Social Housing Renewal Standing Advisory Committee  
Gronn Place, Brunswick West

Report No 3

Report No 3 – Gronn Place, Brunswick West

10 November 2017

**Figure 4: Proposed alternative Development Concept Plan**

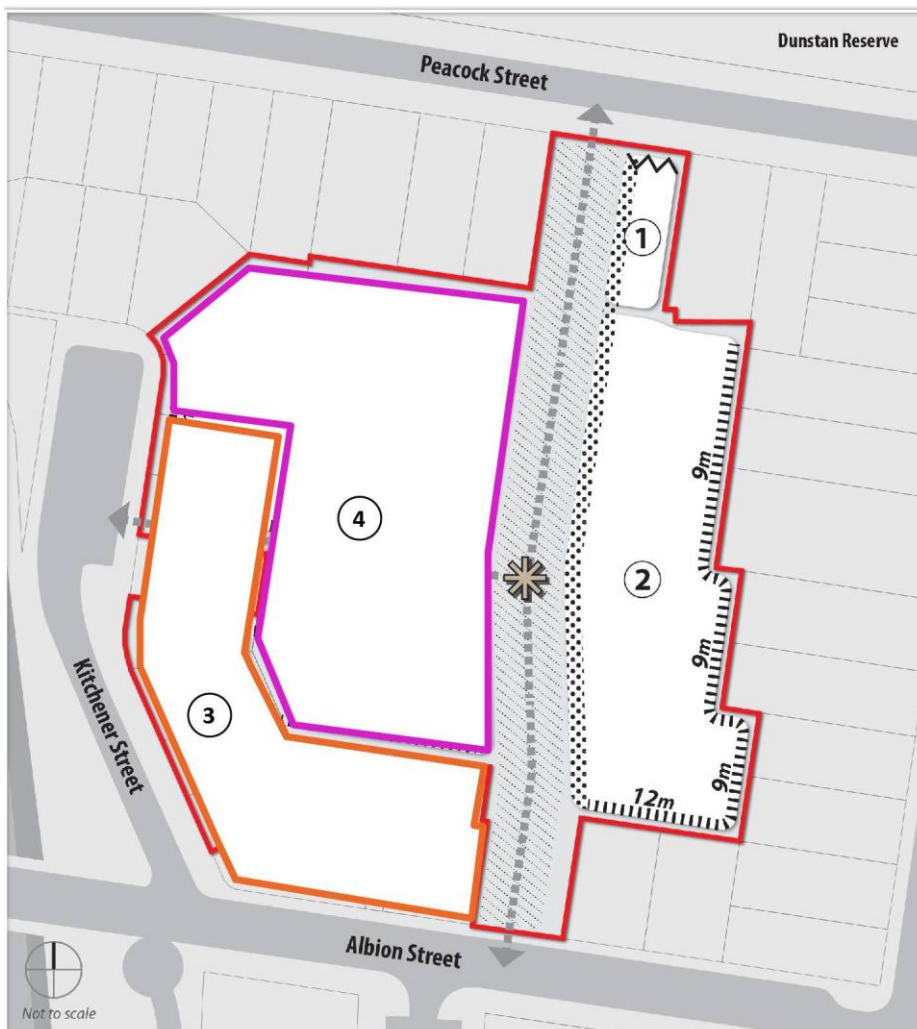
Ms Bell stated that DPO12 should be amended to show the greatest height located along the Kitchener Street frontage. To demonstrate this, she included a revised Concept Plan, designed to show the impact of those recommendations (Figure 4).

In this revised Concept Plan, Ms Bell included 12 Kitchener Street as well as 517 -523 Albion Street in the plan, describing them as ‘remnant’ surrounding properties. Under cross examination, Ms Bell confirmed that she had considered the circumstance where 12 Kitchener Street and the Albion Street properties were not included in the redevelopment

**Concept Plan (Committee Note 1: include Concept Plan, legend and table as an integrated document)**

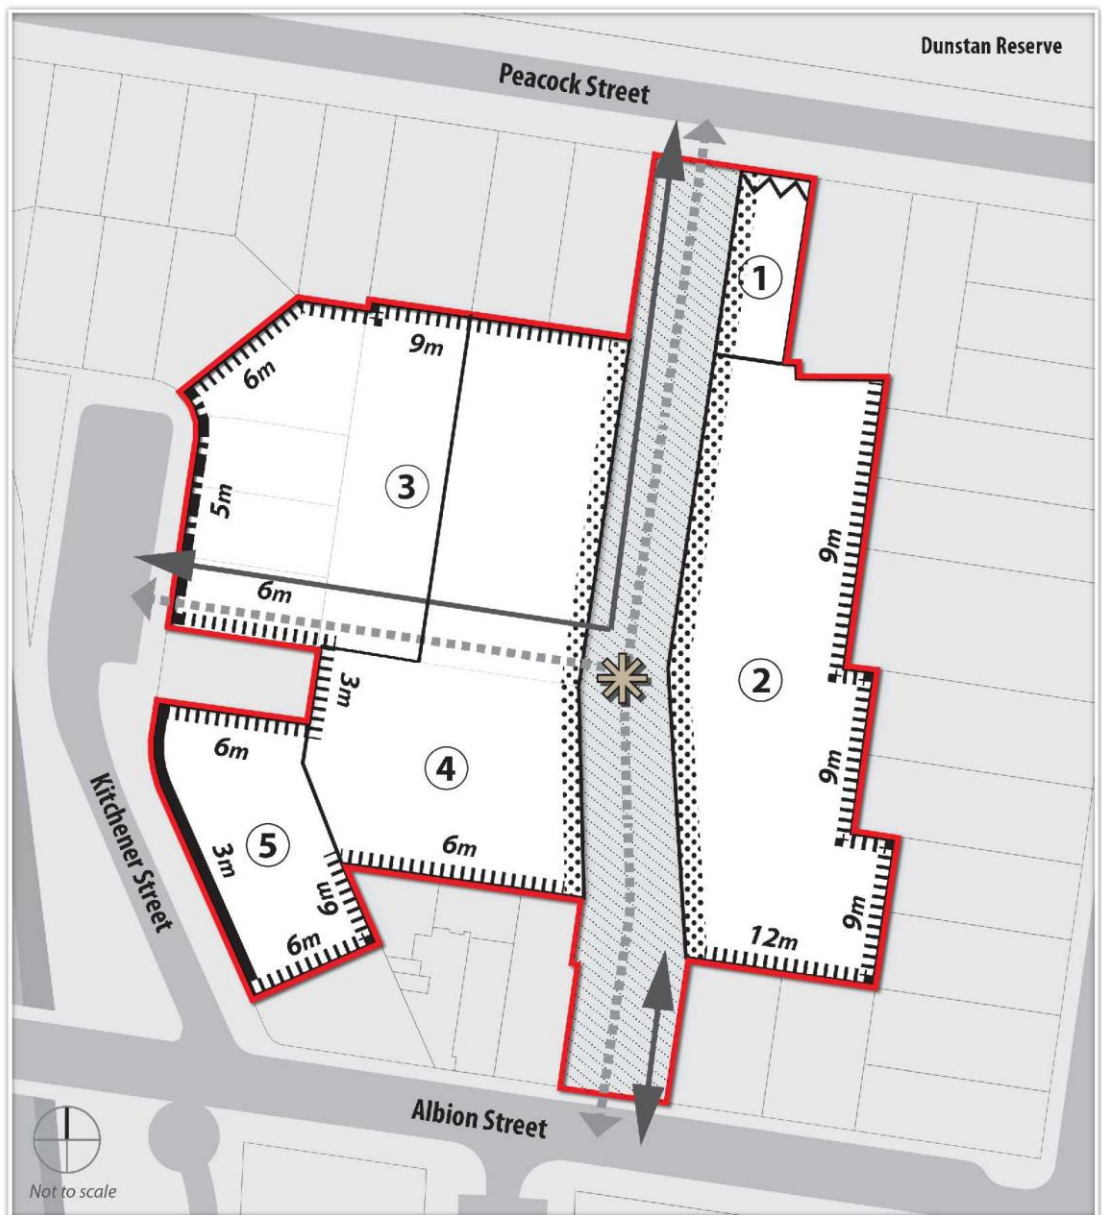
**Committee Note 2: The Concept Plan needs to be amended to address the following:**

- **Interface Treatment A needs to be added to the eastern boundary of the Area 1 and a 3 metres setback specified**
- **Interface Treatment A needs to be shown as 6 metres abutting the east boundary of 12 Kitchener Street**
- **an additional open space area needs to be shown in the northern portion of the site, north of any proposed built form and west of the open space corridor**
- **an indicative location needs to be shown for the replacement community garden.**
